# Access Compliance Report

## Public Rights-of-Way

### (Curb Ramps)

Intersection ID: 29749	Main Street: ARMORCREST_LN	Cross Street: JORDANUS_CT	Location: NE
ADA ID: C37AC8E62140	Ramp Type: BlendTrans2	Initial Pass/Fail: Fail	Overall Compliance: No
		Severity Score: 12.5

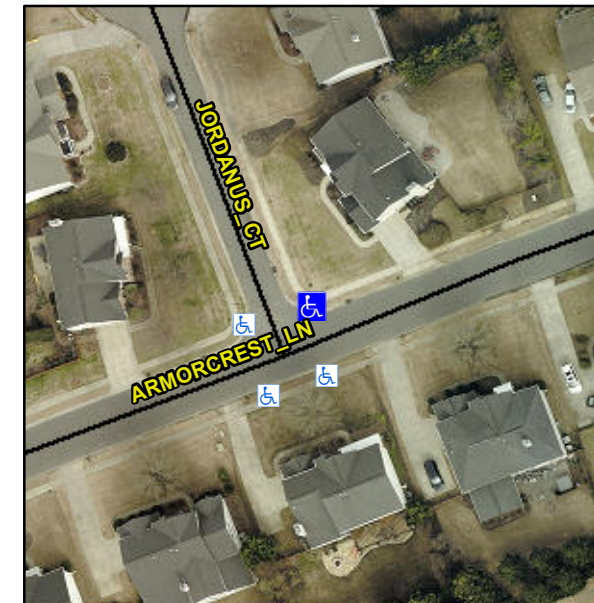
**Not Found, R304.5.3**

Compliance	Description	Data	Compliance	Description	Data
N/A	Ramp Length (in)	48.0	Yes	BlendTrans Slope (%)	3.8
Yes	Ramp Width (in)	56.0	No	BlendTrans XSlope (%)	5.9
N/A	Flare Type LT	N/A	N/A	Flare Type RT	N/A
N/A	Flare Slope LT (%)	N/A	N/A	Flare Slope RT (%)	N/A
N/A	Flare Traversable LT?	N/A	N/A	Flare Traversable RT?	N/A
N/A	Landing Length (in)	N/A	N/A	DWS Provided?	N/A
N/A	Landing Width (in)	N/A	N/A	DWS Contrast?	N/A
N/A	Landing Slope (%)	N/A	N/A	DWS Length (in)	N/A
N/A	Landing X Slope (%)	N/A	N/A	DWS Full Width?	N/A
N/A	Landing Curb? (Y/N)	N/A	N/A	DWS Offset (in)	N/A
N/A	Shared Landing?	N/A			
N/A	Gutter Ponding?	N/A	N/A	Gutter Slope (%)	N/A
N/A	Gutter Lip Ht (in)	N/A	N/A	Gutter X Slope (%)	N/A
N/A	Painted X Walk1?	No	N/A	Painted X Walk2?	No
	X Walk 1 Direction	To SW		X Walk 2 Direction	To S
	X Walk 1 Width (in)	N/A		X Walk 2 Width (in)	N/A
	X Walk 1 Slope (%)	0.6		X Walk 2 Slope (%)	0.4
	X Walk 1 X Slope (%)	0.9		X Walk 2 X Slope (%)	1.2

N/A	Ramp inside XWalk1?	N/A	N/A	Ramp inside XWalk2?	N/A
	Road Slope (%)	2.8		Clear Space?	N/A
	Road X Slope (%)	1.0	N/A	Clear Space to XWalk (in)	N/A
N/A	Any Obstructions?	N/A	N/A	Storm Grate/Utility Hazard?	N/A
	Obstruction Type			Storm Grate/Utility Type	
		N/A			N/A
			Yes	Surface Condition? (G/P)	Good
			No	Curb Slope (%)	10.9

**Remove & Replace Curb Ramp With Two New Directional Ramps or Equivalent.**
